Firestop Submittal Package

078446-Fire-Resistive Joint Systems

Project: Webster University ISB - Drywall SP

SUBMITTAL IDENTIFICATION SHEET

G0202

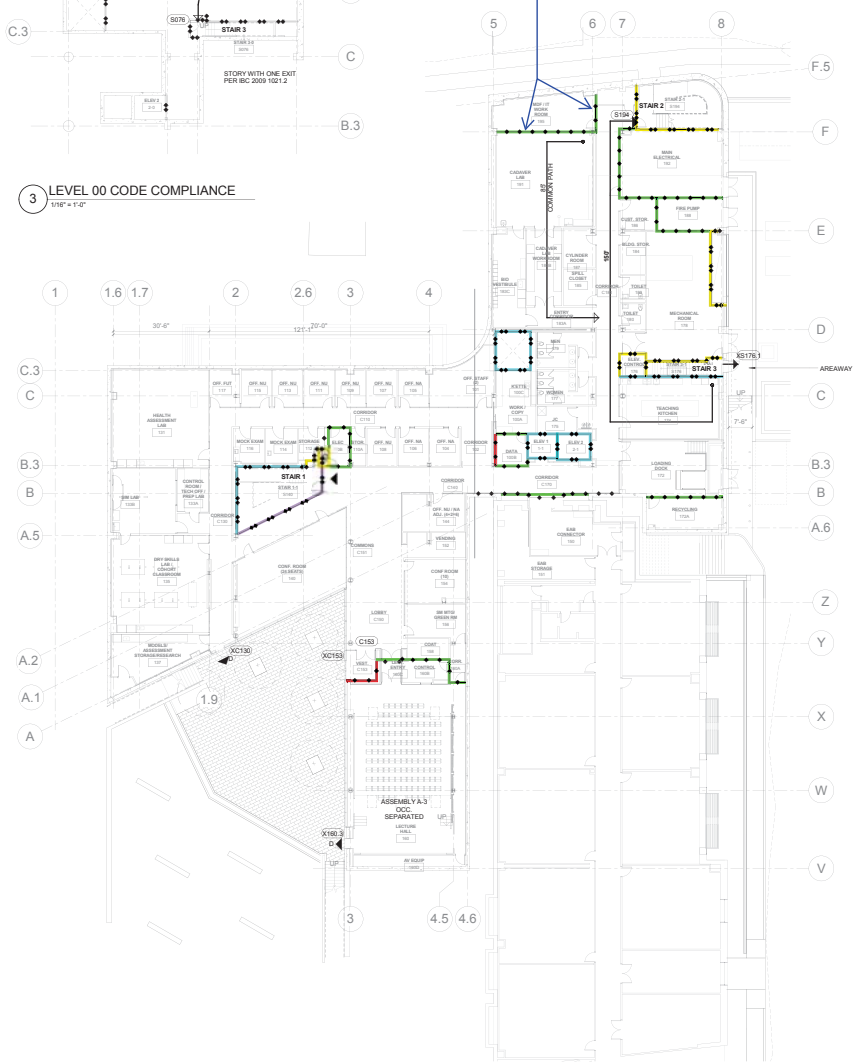
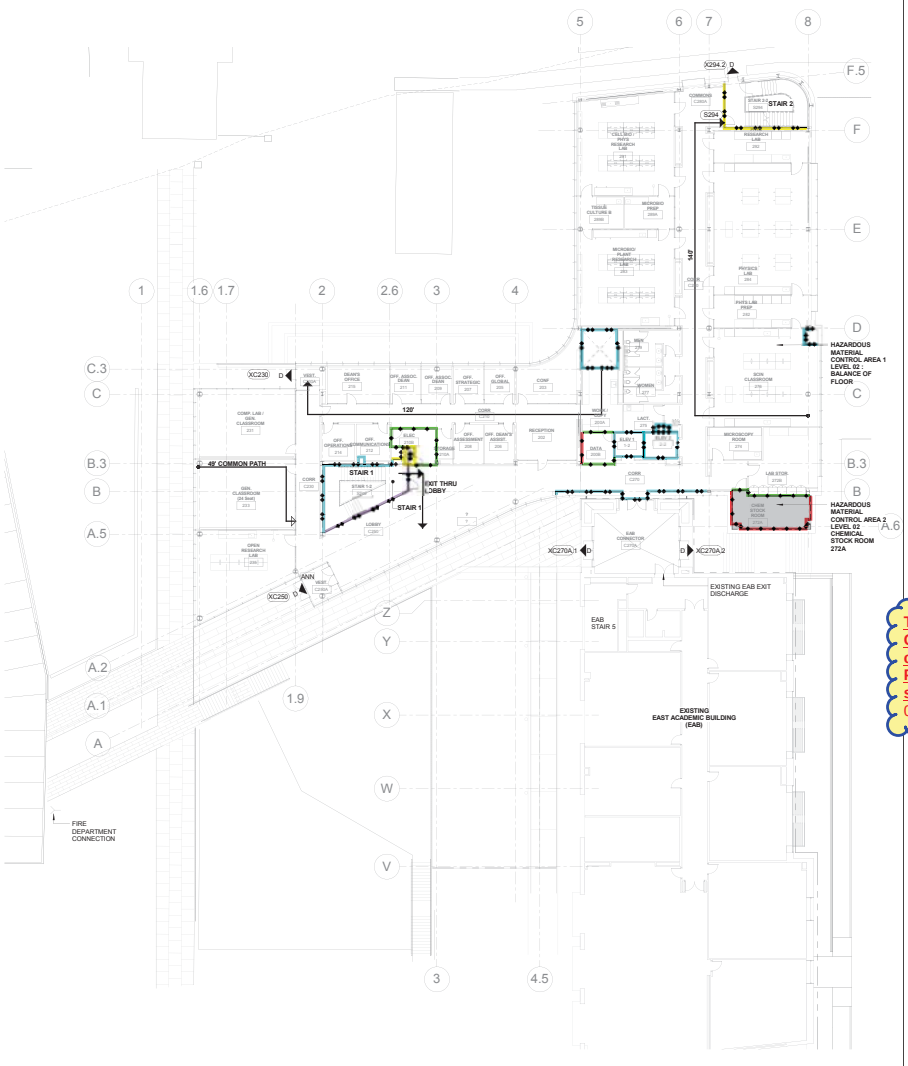
This partition is currently tagged as 'R2' (which is not a rated partition). It should be tagged as 'A2' (a rated partition). No partitions tagged as 'R-' anything should be rated.

This sheet provided by Cannon Design for clarification of "Rated Partition Scope" in fire stopping submittal
02-22-2017

G0203

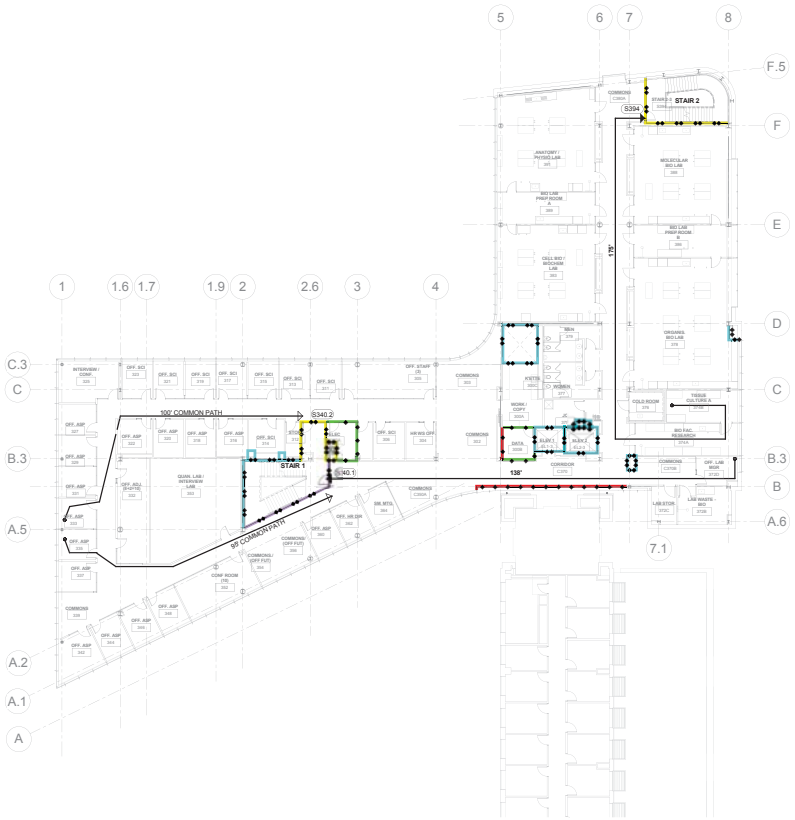
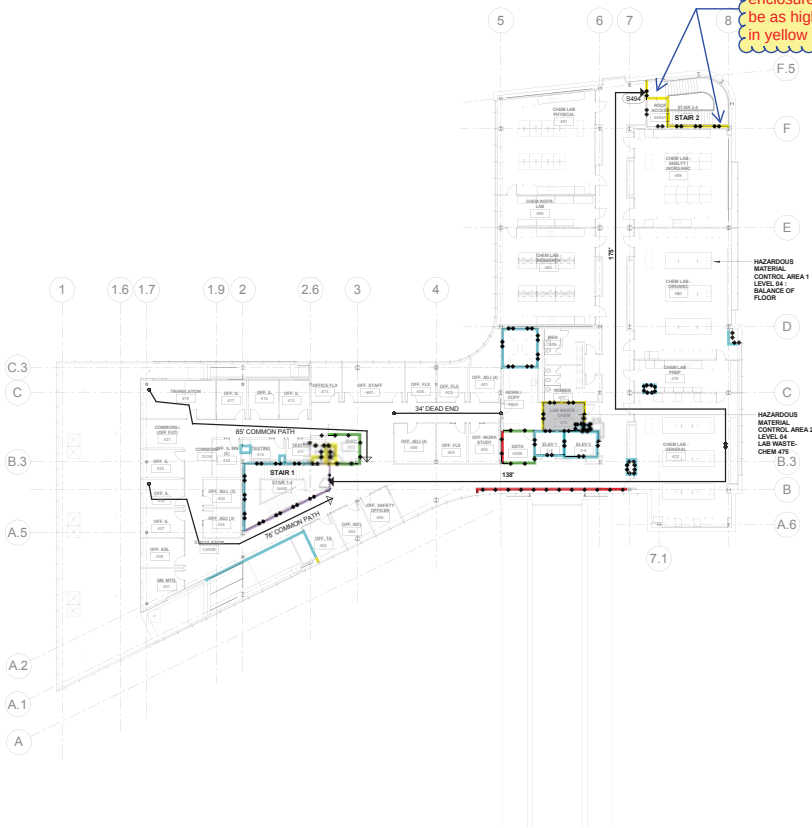
This stair rated enclosure should be as highlighted in yellow here.

This sheet provided by Cannon Design for clarification of "Rated Partition Scope" in fire stopping submittal
02-22-2017

A0101.A

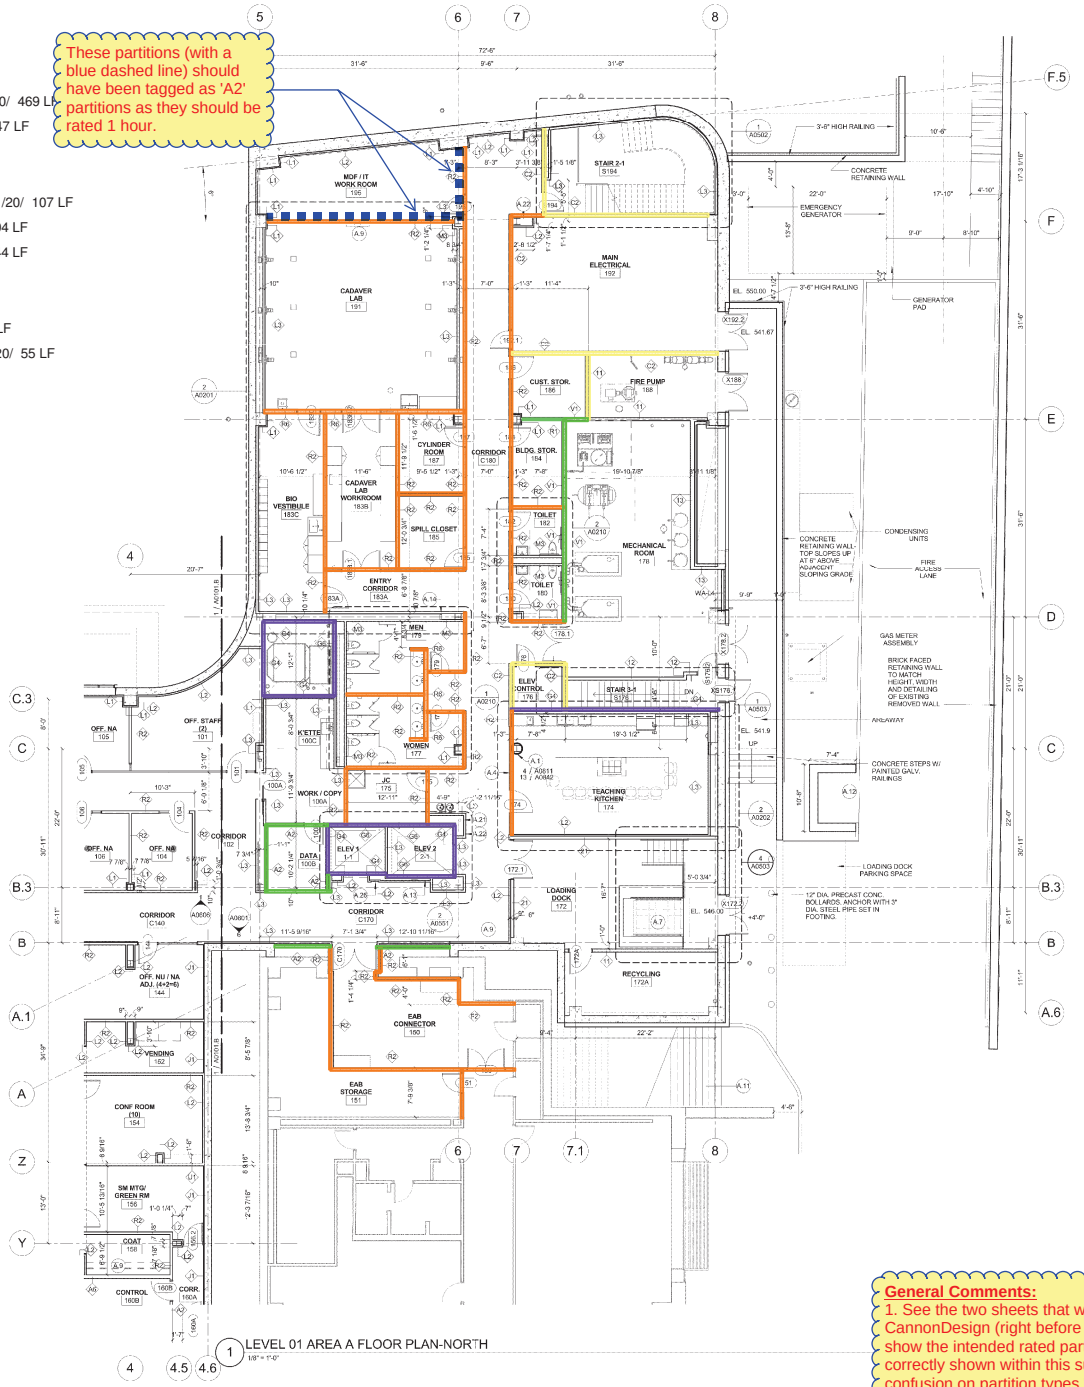
These 'R-' partition types are not fire rated partitions (per sheet A1001) and do not require any fire stopping.

These partitions (with a blue dashed line) should have been tagged as 'A2' partitions as they should be rated 1 hour.

These 'V-' partition types are not fire rated partitions (per sheet A1001) and do not require any fire stopping.

1. See the two sheets that were added into this submittal by CannonDesign (right before Hilti's marked up plans) which show the intended rated partitions vs. the "rated" partitions not correctly shown within this submittal as it was submitted (due to confusion on partition types "R-" & "V-" which are not fire rated partitions - they are only sound rated).

2. Rated cmu walls did not appear to be accounted for within the Hilti marked up plans. CannonDesign assumes that these cmu walls need fire stopping too.

A0101.B

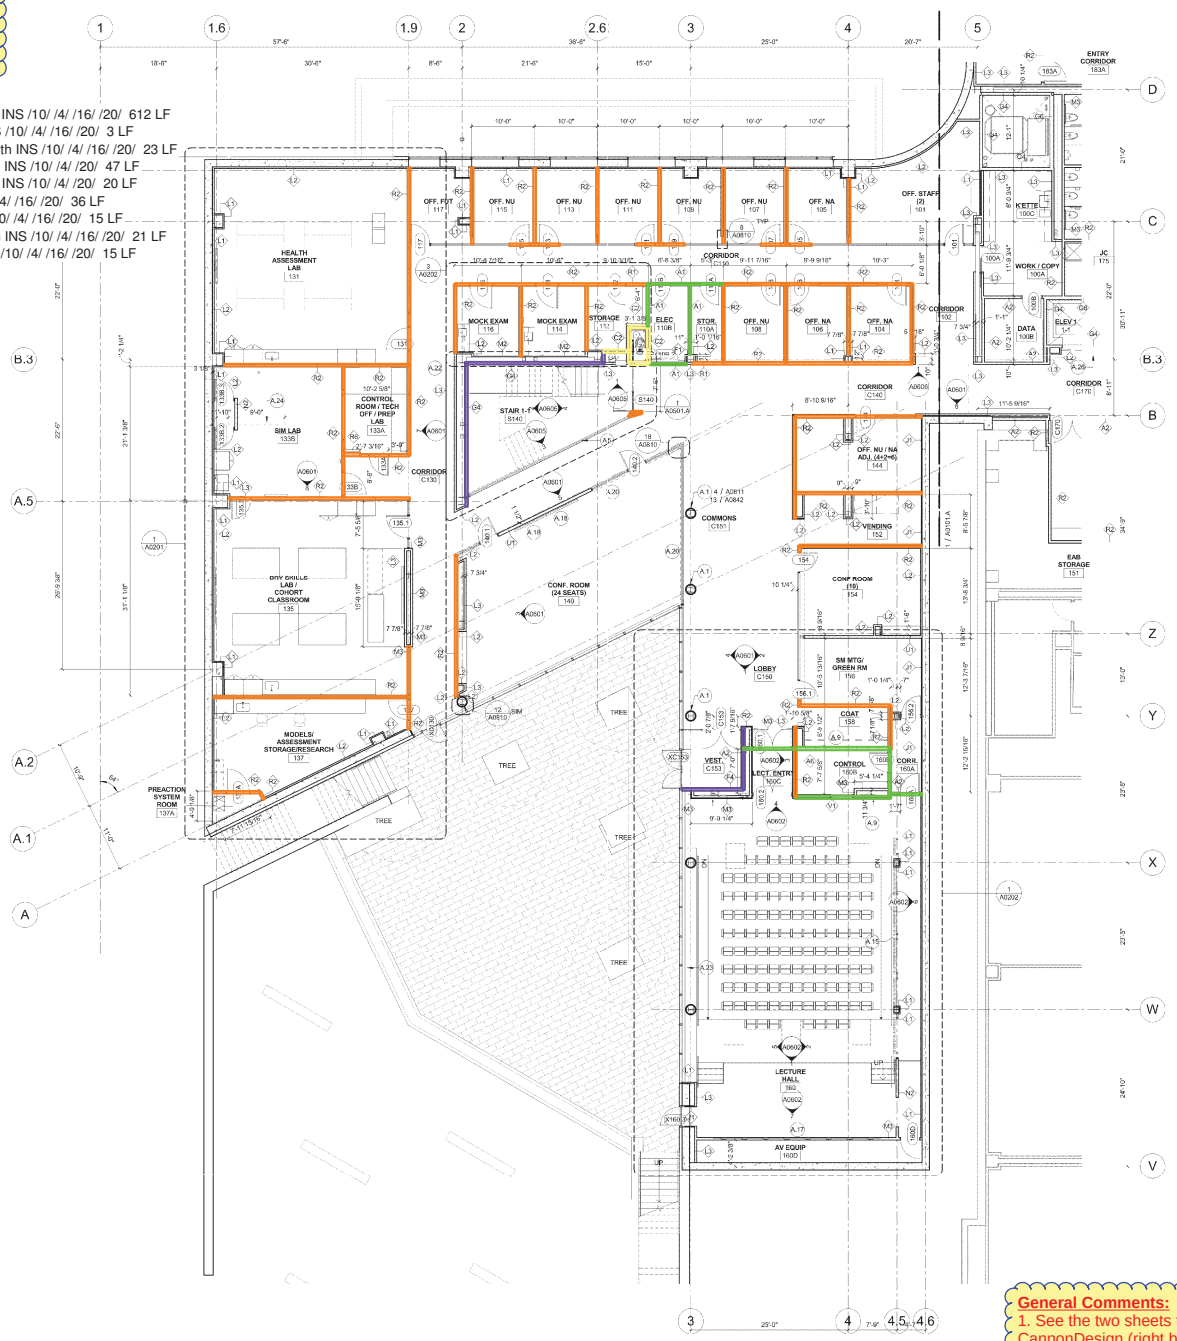
These 'R-' partition types are not fire rated partitions (per sheet A1001) and do not require any fire stopping.

These 'V-' partition types are not fire rated partitions (per sheet A1001) and do not require any fire stopping.

1. See the two sheets that were added into this submittal by CannonDesign (right before Hilti's marked up plans) which show the intended rated partitions vs. the "rated" partitions not correctly shown within this submittal as it was submitted (due to confusion on partition types "R-" & "V-" which are not fire rated partitions - they are only sound rated).

2. Rated cmu walls did not appear to be accounted for within the Hilti marked up plans. CannonDesign assumes that these cmu walls need fire stopping too.

A0102.A

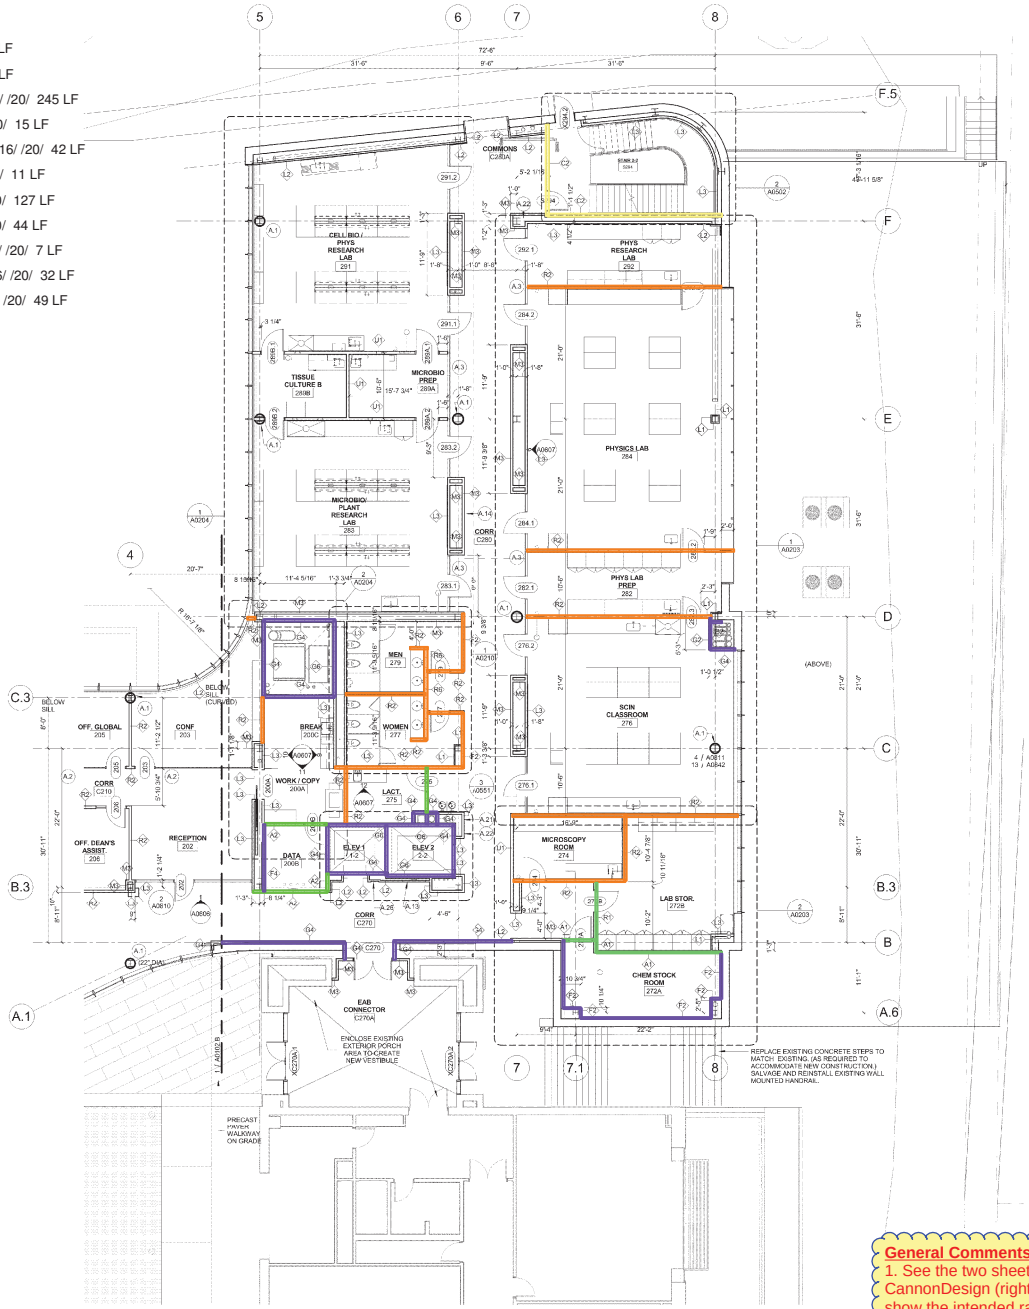
These 'R-' partition types are not fire rated partitions (per sheet A1001) and do not require any fire stopping.

1. See the two sheets that were added into this submittal by CannonDesign (right before Hilti's marked up plans) which show the intended rated partitions vs. the "rated" partitions not correctly shown within this submittal as it was submitted (due to confusion on partition types "R-" & "V-" which are not fire rated partitions - they are only sound rated).

2. Rated cmu walls did not appear to be accounted for within the Hilti marked up plans. CannonDesign assumes that these cmu walls need fire stopping too.

LEVEL 02 AREA B FLOOR PLAN

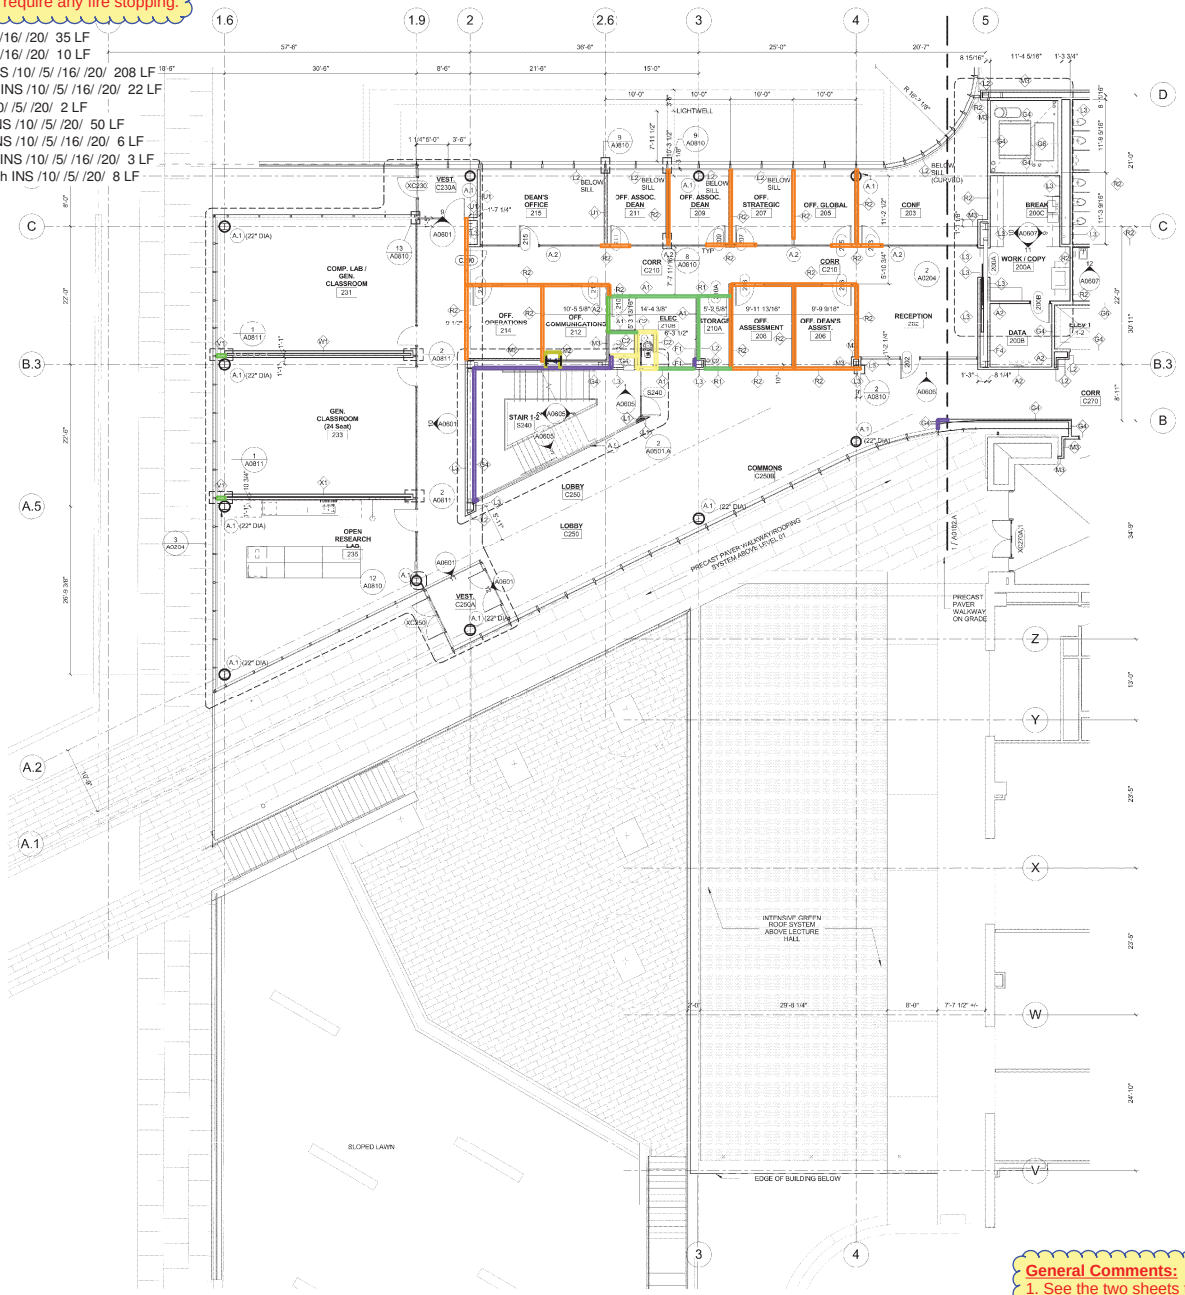
These 'R-' partition types are not fire rated partitions (per sheet A1001) and do not require any fire stopping.

These 'V-' partition types are not fire rated partitions (per sheet A1001) and do not require any fire stopping.

1. See the two sheets that were added into this submittal by CannonDesign (right before Hilti's marked up plans) which show the intended rated partitions vs. the "rated" partitions not correctly shown within this submittal as it was submitted (due to confusion on partition types "R-" & "V-" which are not fire rated partitions - they are only sound rated).

2. Rated cmu walls did not appear to be accounted for within the Hilti marked up plans. CannonDesign assumes that these cmu walls need fire stopping too.

LEVEL 03 AREA A FLOOR PLAN

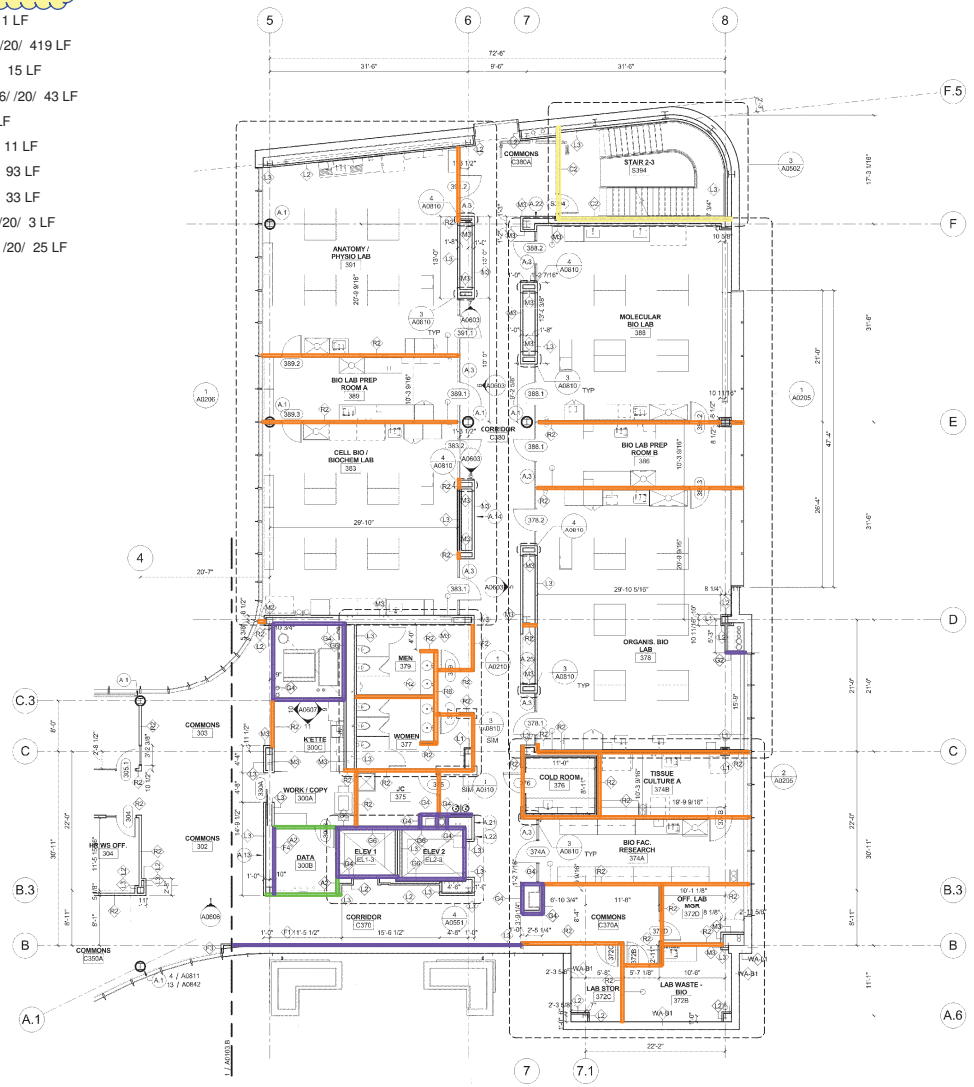
These 'R-' partition types are not fire rated partitions (per sheet A1001) and do not require any fire stopping.

1. See the two sheets that were added into this submittal by CannonDesign (right before Hilti's marked up plans) which show the intended rated partitions vs. the "rated" partitions not correctly shown within this submittal as it was submitted (due to confusion on partition types "R-" & "V-" which are not fire rated partitions - they are only sound rated).

2. Rated cmu walls did not appear to be accounted for within the Hilti marked up plans. CannonDesign assumes that these cmu walls need fire stopping too.
